## SERVICE BULLETIN

**APPLICABILITY:** 2013-14MY Impreza 2.0L NA Models  
 2013-14MY XV Crosstrek, Including Hybrid Model (HEV)

**NUMBER:** 11-149-14R  
**DATE:** 11/06/14  
**REVISED:** 12/10/14

**SUBJECT:** Reprogramming File Availability for Oil Level Detection

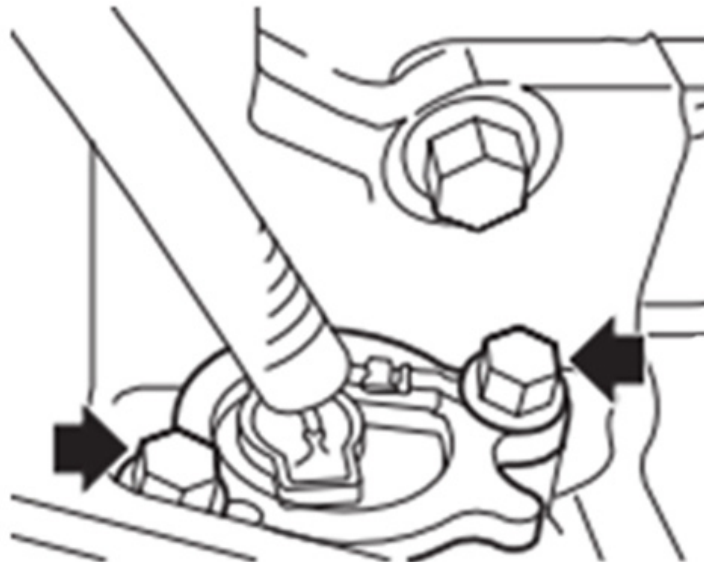
**Step 3** - Once the ECM reprogramming has been completed and the oil level switch wiring has been confirmed to be OK, proceed with replacing the oil level switch assembly shown in the illustration below following the procedure outlined in the applicable Service Manual. Torque the 2 retaining bolts to 6.4 Nm (56 inch-pounds). Torque the 2 retaining bolts to 6.4 Nm (56 inch-pounds).
